Ardmore Park Quarry – Modification 3

Revised Noise Impact Assessment

RESPONSE TO SUBMISSIONS

**Ardmore Park Quarry - Modification 3
Noise Impact Assessment
Response to EPA Submission**

Figure 3 Sensitive Receptor Locations

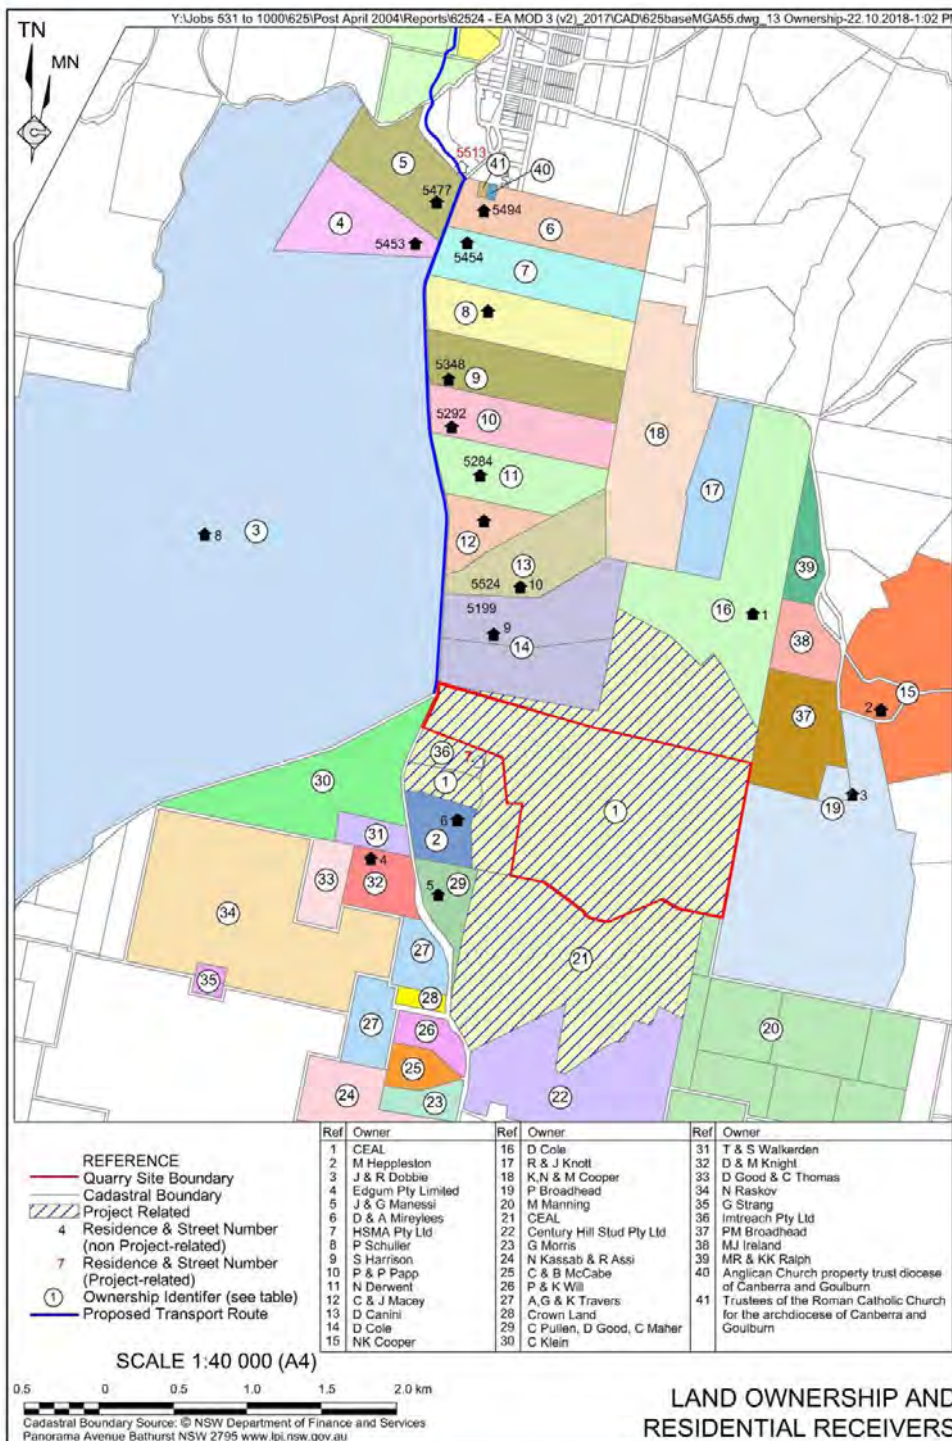
Figure 3 Sensitive Receptor Locations in the NIA appears to indicate that Residence 6 is project related, however the NIA provides calculations for that Residence as if it were not project related. Table 1 of the AQIA indicates that Receptor R6 is a project owned residence.

- *Recommendation: Clarify which sensitive receptors are project related and which are not, as this has implications from a noise perspective in terms of agreed/acceptable impacts.*

It is confirmed that Residence 6 is not Project related (as reflected in Figure 3 of the Revised NIA). Residence 6 has been assessed as a non-project related sensitive receiver throughout the Revised NIA.

Figure 4 Basalt Extraction

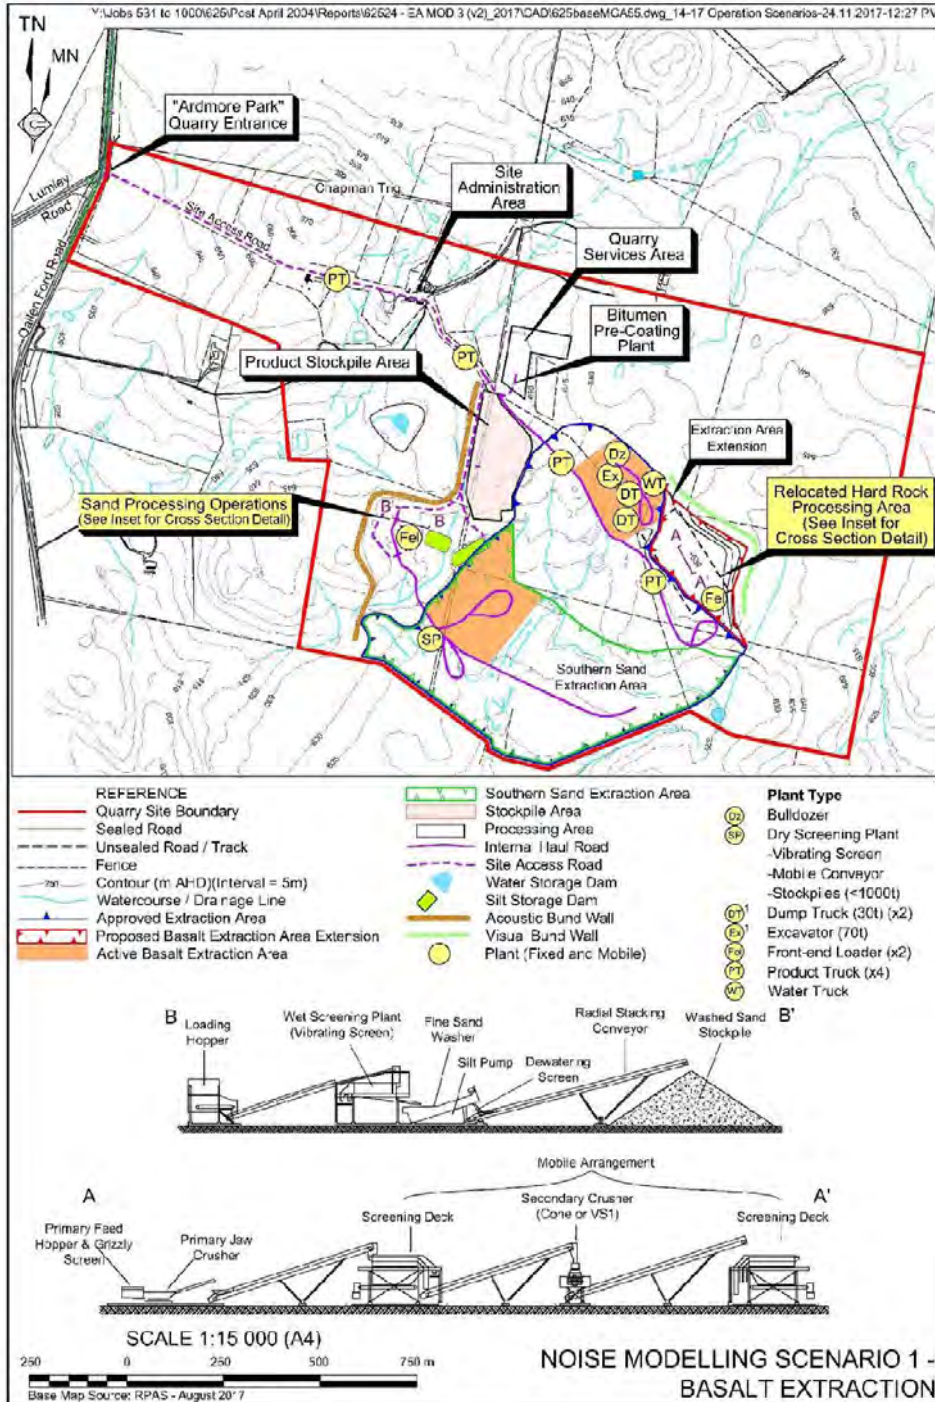
The predicted noise levels for equipment operating in-pit are significantly lower than those calculated by the EPA with a simple distance calculation to R3. The proponent should provide adequate detail on the modelled depth of the equipment operating in the quarry pit, as the EPA cannot verify the modelled results in the NIA without modelling details such as equipment heights/in-pit depths.

- *Recommendation: That the proponent provide adequate detail on the modelled depth of the equipment operating in the pit.*

The EPA notes that some of the proposed equipment appears to have not been included in the modelling. For example, Figures 4 and 5 of the NIA indicate 'front-end loader x 2', however Table 8 indicates only one front-end loader was included in the model. Similarly, the conveyors indicated in Figure 4 (Basalt processing) are also not included in Table 8 of the NIA.

Figure 4 of the 2017 NIA / Revised NIA shows the basalt extraction operational scenario used in the noise modelling. The elevations of operating equipment are as follows:

- The in-pit basalt crushing equipment and FEL would be operated at 630m AHD.
- The Sand Screening and Washing Plant and FEL would be operated at 640m AHD.
- The Dozer (Dz) operating to the north would be at surface (soil / overburden stripping activities) at approximately 640m AHD.
- The excavator (Ex), dump trucks (DT) and water truck (WT) would commence operations near surface, however, operate at progressively lower elevations. Accordingly, the noise sources have been modelled 5m to 10m below surface (630m to 635m AHD).
- The road trucks (PT) travel at surface which can be identified from the 5m contours on the figure (progressively rising from 635m AHD to 660m AHD).
- The Dry Screening Plant (SP) would operate at 620m AHD.

The equipment schedule presented in Table 8 of the 2017 NIA has been revised in Table 9 of the Revised NIA. The sound power level associated with conveyors and conveyor drives has been included into sound power level nominated for the primary piece of equipment feeding the conveyor.
